CUSTOMER NOTIFICATION

SUD-DT-03-0237-E

June 6, 2003

# 78K0 Series Assembler Package RA78K0 V3.51 Operating Precautions

The address and size in (4) Generation of stack decision symbols specification (-S/-NS) [Example of use] on page 181 has been corrected as follows.

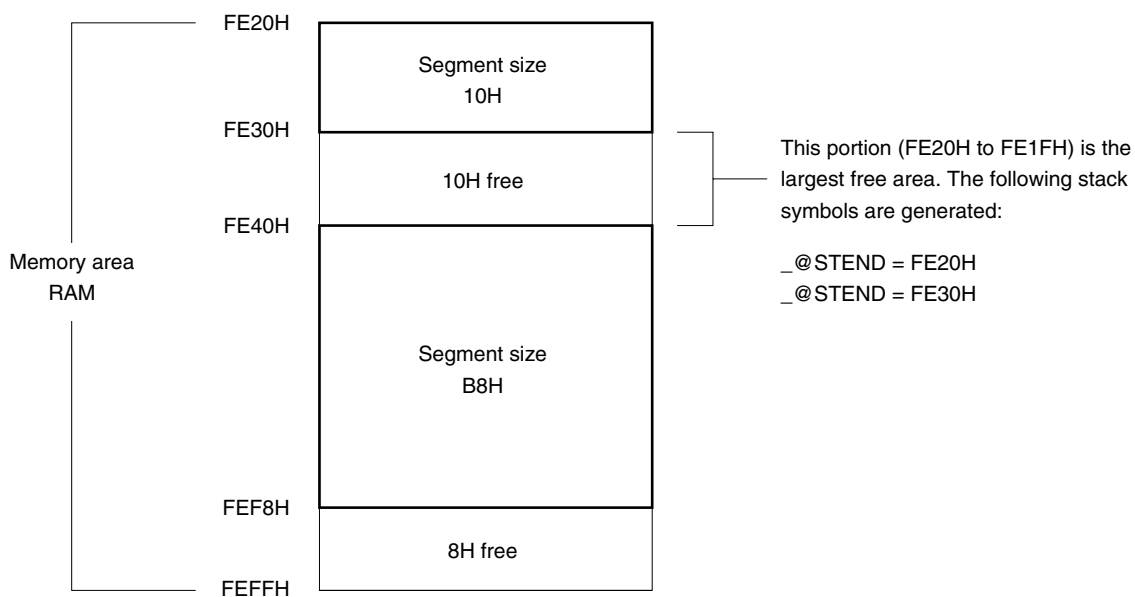
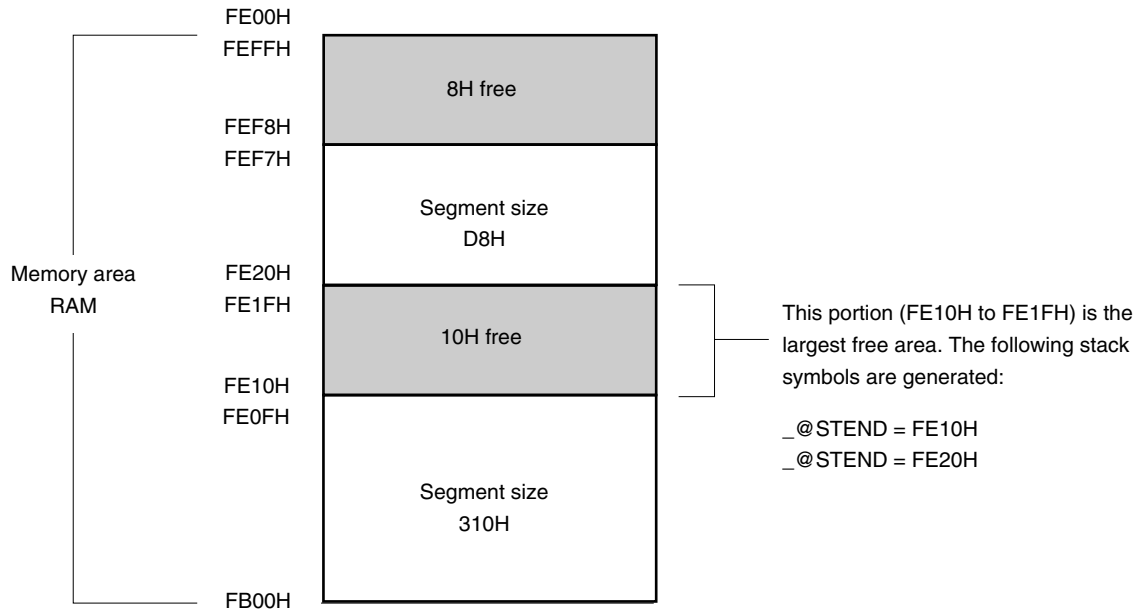
<Incorrect>

Reserve the stack area in memory area RAM (however, the linker will assume that a segment of size 10H in RAM and a segment of size B8H located in the saddr area are input).

<Correct>

Reserve the stack area in memory area RAM (however, the linker will assume that a segment of size 310H in RAM and a segment of size D8H located in the saddr area are input).
